TECHNICAL NOTE				VELOCITY4	
Client	Kitewood Estates Ltd.			Page No.	1 of 19
Project	Site A Willow Way, Sydenham			Project No.	22/089
Subject	Technical Note in Support of Planning Appeal			Document No	TN004
Prepared By	PM/AM	Checked and Authorised By	MK	Date	11 May 2023

**Table 1-1: LBL Officer Report Comments on the Application and VTP Response**

**Table 1-2: LBL Transport Comments on the Application and VTP Response**

SWEPT PATH ANALYSIS OF WILLOW WAY DEMONSTRATING SERVICING BY MULTIPLE SITES

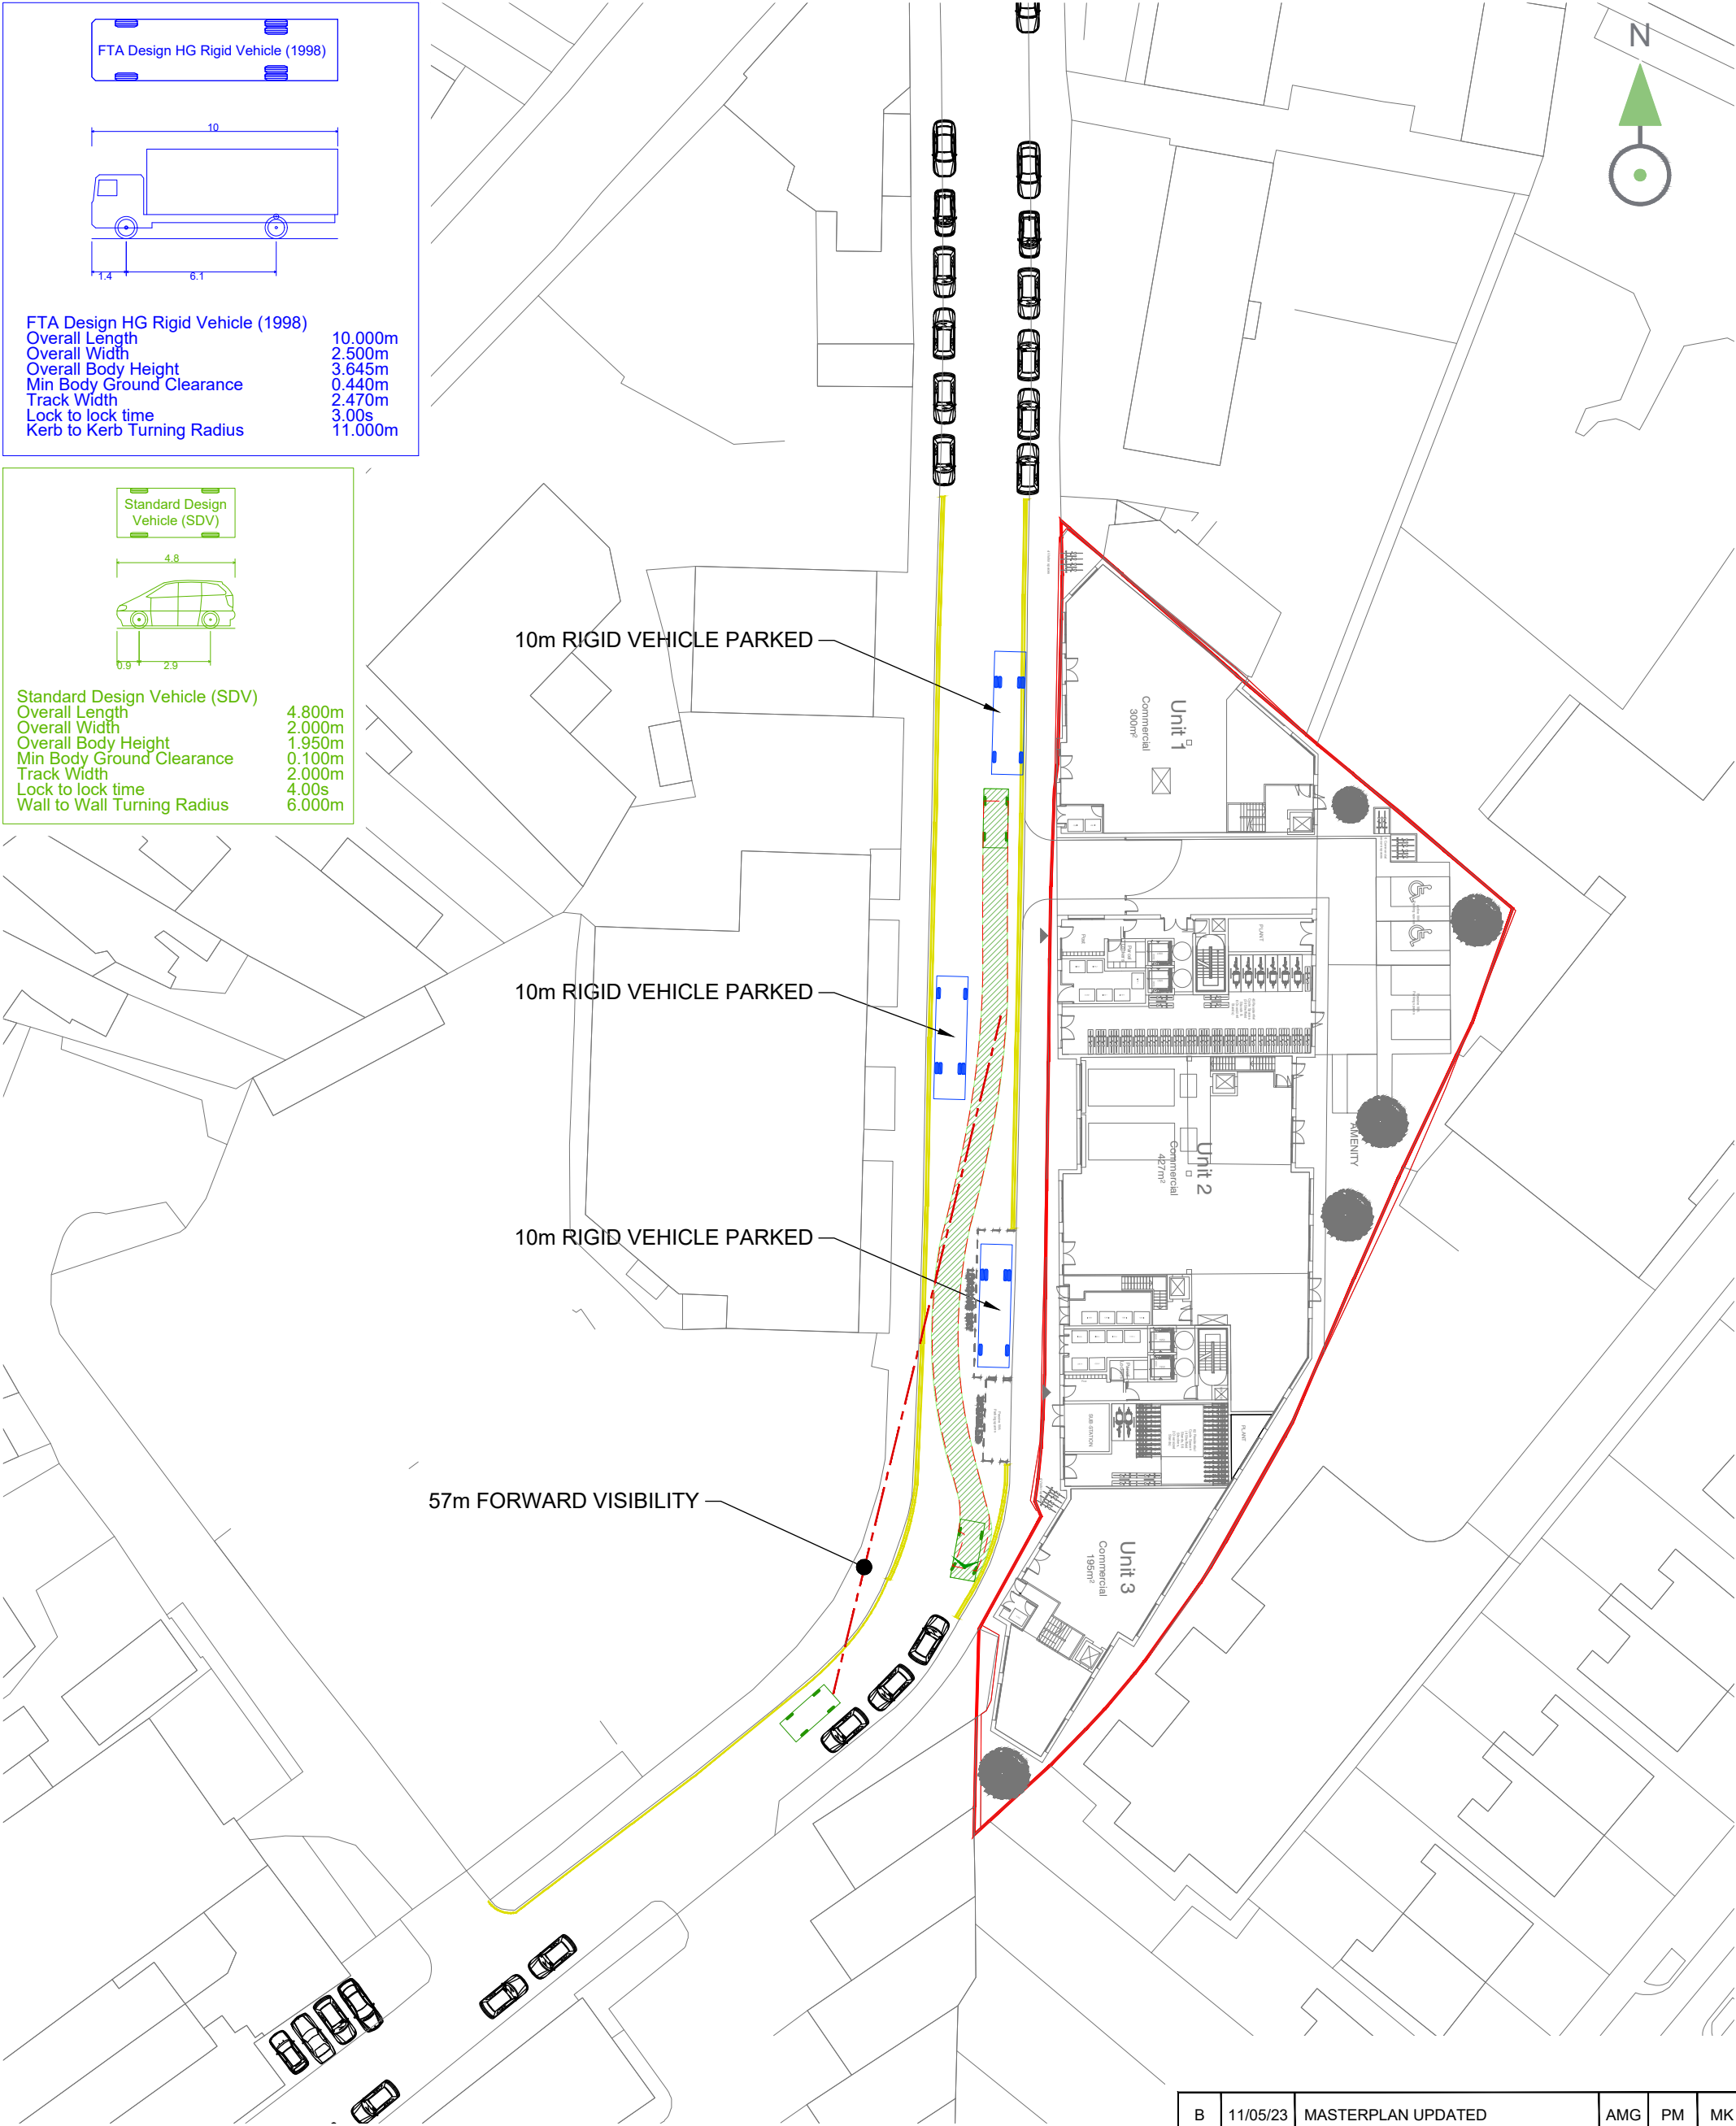
308	<p><b>Servicing Demand:</b> The Highways officer has provided the following comments: There are concerns with regards to the proposed on-street loading strategy and if this is sufficient to accommodate all associated trips. The loading bay will only be able to accommodate one 10m ‘box van’ type vehicle at any one time, or it will only be able to accommodate 2 ‘standard’ sized vehicles at any one time.</p> <p>There are concerns with service and delivery vehicles having to park elsewhere along Willow Way when the loading bay is occupied.</p> <p>Further details will need be provided to evidence this loading bay is sufficient for the overall site including refuse collection.</p>	<p>The proposed servicing demand has been demonstrated to be of a similar scale to the existing demand in the area and is likely to be accommodated easily within the proposed loading bay. Details of this arrangement have been set out within this Technical Note in response to paragraph 296-298 above.</p> <p>In the event that two 7.5t box van type vehicles propose to service the Site simultaneously, it may be necessary for one to stop on-street on Willow Way to unload. As it is proposed to provide double yellow lines along the frontage of the Site, which can be used for loading/unloading for a maximum of 40 minutes (as per section 5.18 of Lewisham Borough Council’s Parking Policy, March 2023), it is expected that there will be capacity on-street for vehicles to stop and undertake short term servicing, and that this will have no material impact on amenity on Willow Way.</p>

PARAGRAPH	PLANNING OFFICER / LBL HIGHWAYS COMMENT	VTP RESPONSE
	Highways would prefer servicing and delivery to be kept within the site where possible. If this is not possible the above concerns will need to be addressed in detail.	<p>This arrangement will also provide a significant improvement compared to the existing situation in which, apart from some existing units along Willow Way having dedicated service yards, servicing must take place amongst existing cars that are parked on-street and that hinder access to the existing units.</p> <p>Refuse collection typically takes place early in the day when the frequency of deliveries will be low. Refuse collection is also most efficiently taken place by the Refuse Collection Vehicle (RCV) stopping in close proximity to each waste store, which is expected to be possible due to the double yellow lines restricting general parking. This is a standard arrangement, and it is not considered that there would be any hinderance to the refuse collection activities associated with the units to be serviced from Willow Way. See <b>APPENDIX C</b>.</p>

PLANS DEMONSTRATING REFUSE CARRY AND DRAG DISTANCES

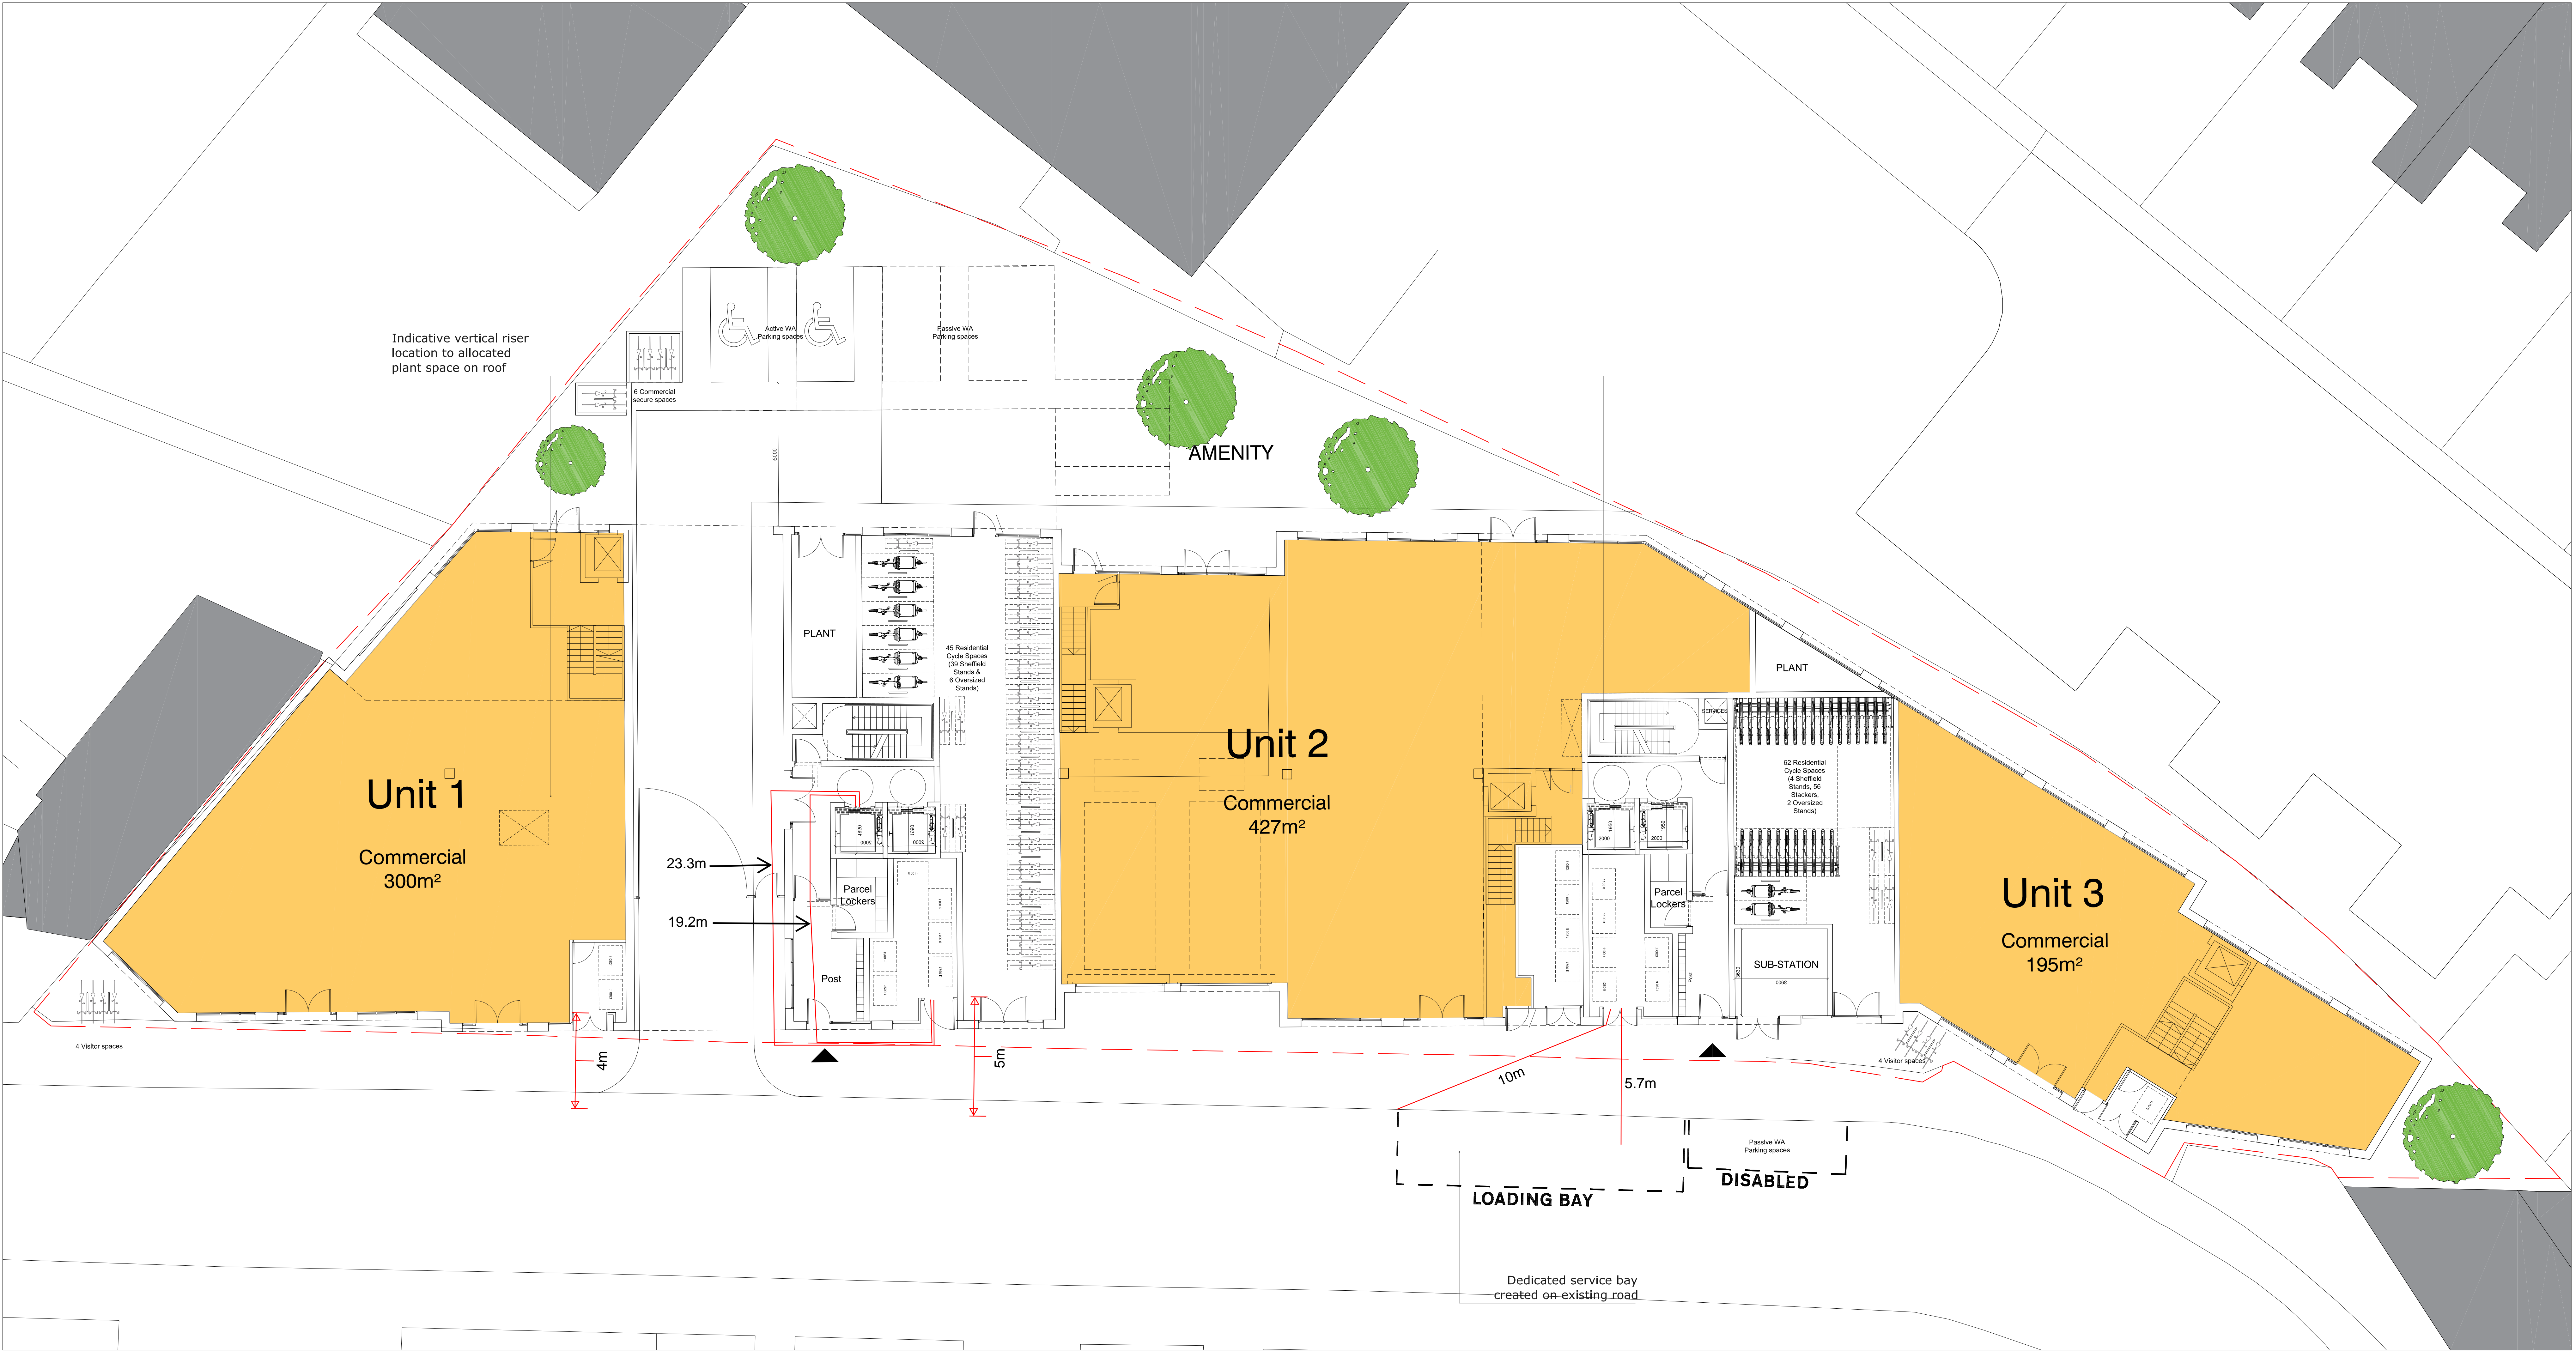
309	<p><b><u>Refuse Management:</u></b></p> <p>Refuse officers should also be consulted with regards to the size and location of the bin store. It should be reminded that residents are not permitted to carry refuse bins more than 30m to the bin collection point and waste operatives are restricted to a maximum 10m drag distance on collecting bins. It is suggested that a more detailed refuse strategy at this stage is presented to show the proposals adhere to the above requirements. Once approved this should be secured by condition.</p>	<p>The location of the refuse stores has been optimised as much as possible to minimise drag distances within the site's constraints. Whilst additional doors to the refuse stores would likely achieve the 30m carry distance, this would introduce unacceptable fire risks for the units.</p> <p>As shown on the drawings in <b>APPENDIX D</b>, only 11 of the total of 60 flats exceed the 30m drag distance to the refuse stores, which the average level of exceedance being just 3.3m over the permitted 30m, and a maximum of 36.5m. The impact of this slight exceedance is considered to be immaterial and is unlikely to be noticed by residents.</p> <p>RCV's typically stop on-street close to refuse stores to minimise drag distances, and the drawing in <b>APPENDIX D</b> demonstrates that drag distances are likely to be less than the maximum 10m distance for all refuse stores.</p>
